***Development Special Use Permit #2015-0008
Transportation Management Plan SUP #2015-0045
2200-A Mill Road – Eisenhower East Block 20***

Application	General Data	
Project Name: Eisenhower East Block 20	PC Hearing:	June 2, 2015
	CC Hearing:	June 13, 2015
	If approved, DSUP expiration:	June 13, 2018 (36 months from expiration date)
	Site Area:	173,135 sf (3.97 ac)
Location: 2200 Mill Road	Zone:	CDD#2
	Proposed Use:	Office
	Gross Floor Area:	585,000 sf
Applicant: LSREF2 Clover Property 12, LLC, represented by Duncan Blair	Small Area Plan:	Eisenhower East
	Green Building:	LEED Silver

Purpose of Application
Approval of a three year extension for a previously approved Development Special Use Permit, DSUP #2012-0003 for Block 20 in the Eisenhower East Small Area Plan area

Figure 1020.1.6.2 Example Building Footprint Sign

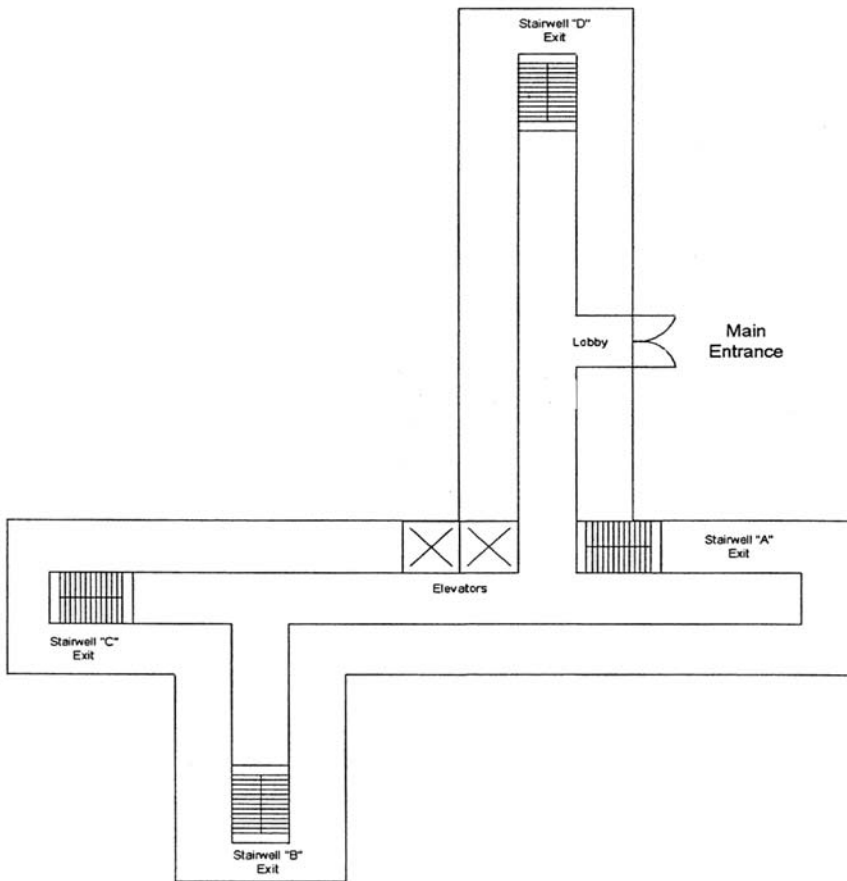
Footprint requirements. In buildings greater than three stories where there is no graphic representation of the building footprint, a simplified building schematic must be display in the lobby. The simplified building footprint shall be an overhead view of the buildings exterior and the general layout of the lobby of the first floor. Stairways shall be denoted by letter as stated in section 1020.1.6. (See Figure 1020.1.6.2)

Figure 1020.1.6.2 Example Building Footprint Sign

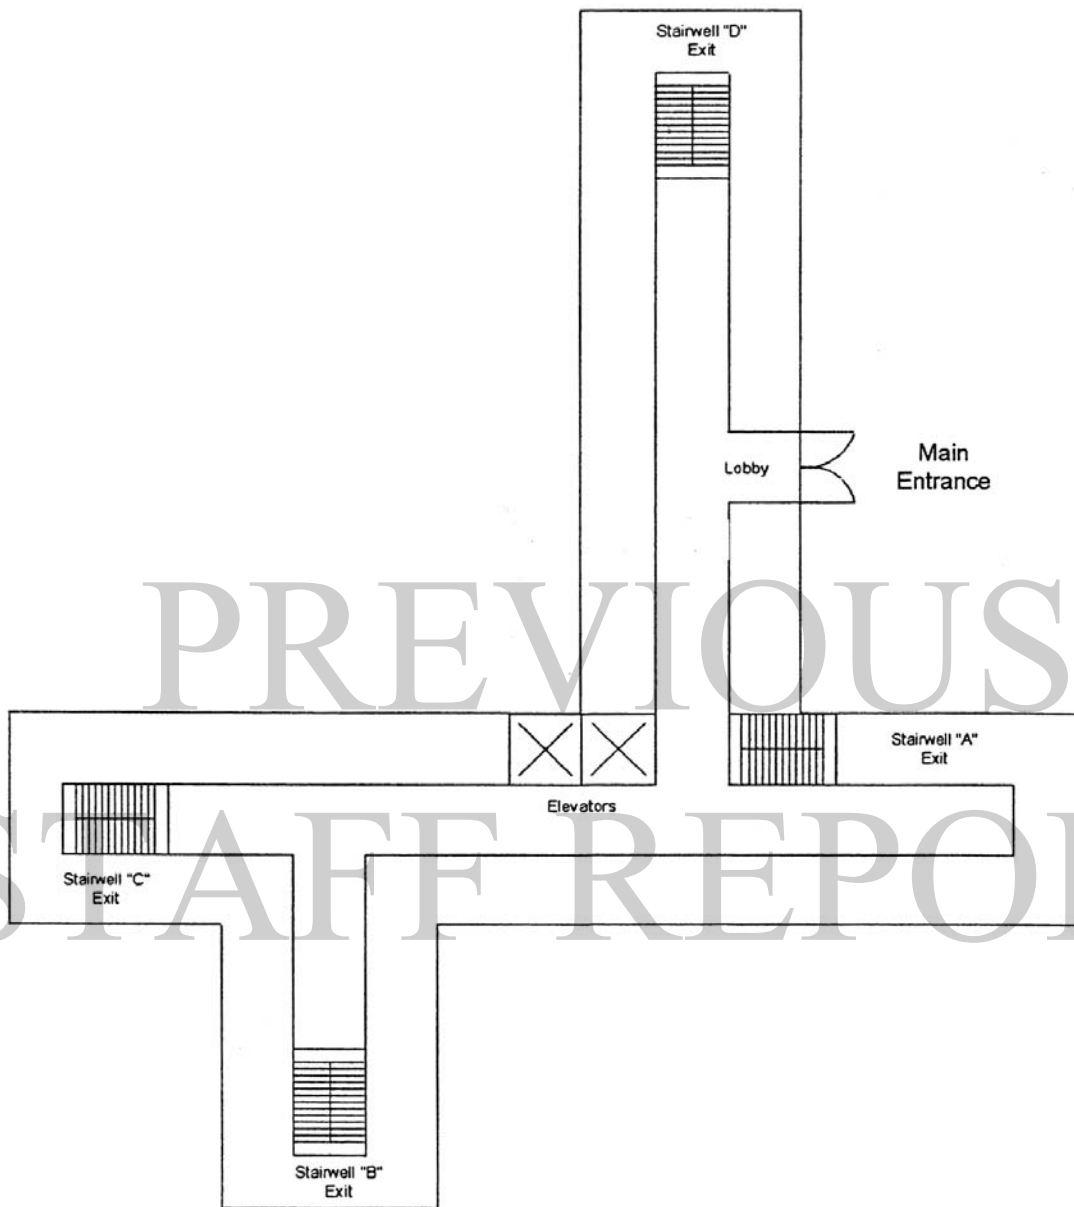
C -9 Provide Stairway Identification. A sign shall be provided at each floor landing in interior vertical exit enclosures connecting more than three stories designating the floor level, the terminus of the top and bottom of the stair enclosure and the identification of the stair. The signage shall also state the story of, and the direction to the exit discharge and the availability of roof access from the stairway for the fire Department, in accordance with USBC 1020.1.6. and the City Fire Prevention Code. Building footprint map is not required if graphic annunciator is installed.

simplified building footprint shall be an overhead view of the buildings exterior and the general layout of the lobby of the first floor. Stairways shall be denoted by letter as stated in section 1020.1.6. (See Figure 1020.1.6.2)

Emergency Vehicle Easements

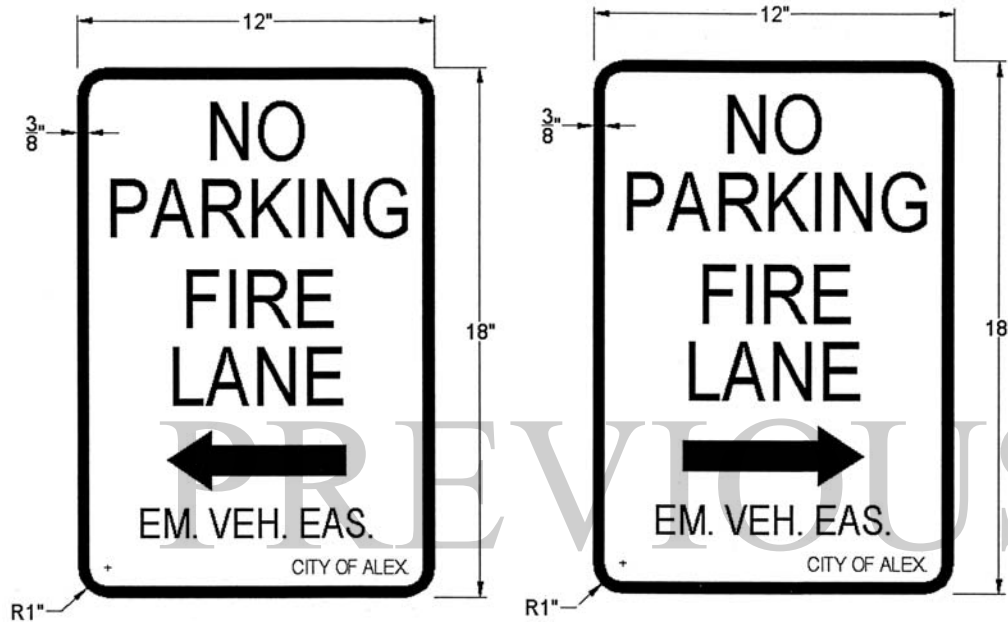
- C-7 The final site plans shall show placement of emergency vehicle easement signs. See sign detail and placement requirements below.

Figure 1020.1.6.2 Example Building Footprint Sign

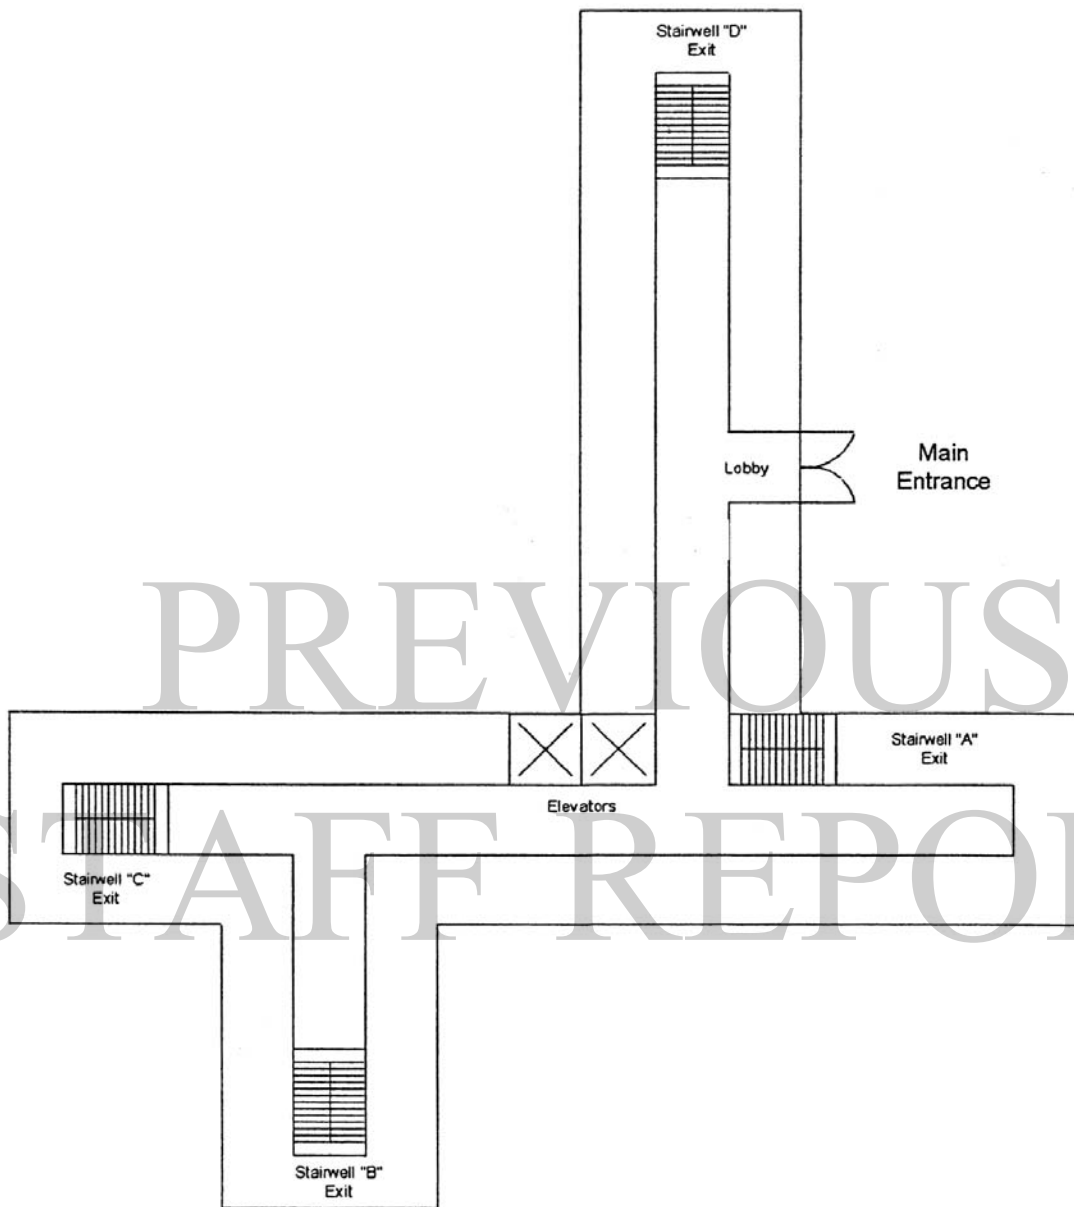
- C-9 Provide Stairway Identification. A sign shall be provided at each floor landing in interior vertical exit enclosures connecting more than three stories designating the floor level, the terminus of the top and bottom of the stair enclosure and the identification of the stair. The signage shall also state the story of, and the direction to the exit discharge and the availability of roof access from the stairway for the fire Department, in accordance with USBC 1020.1.6. and the City Fire Prevention Code. Building footprint map is not required if graphic annunciator is installed.

simplified building footprint shall be an overhead view of the buildings exterior and the general layout of the lobby of the first floor. Stairways shall be denoted by letter as stated in section 1020.1.6. (See Figure 1020.1.6.2)
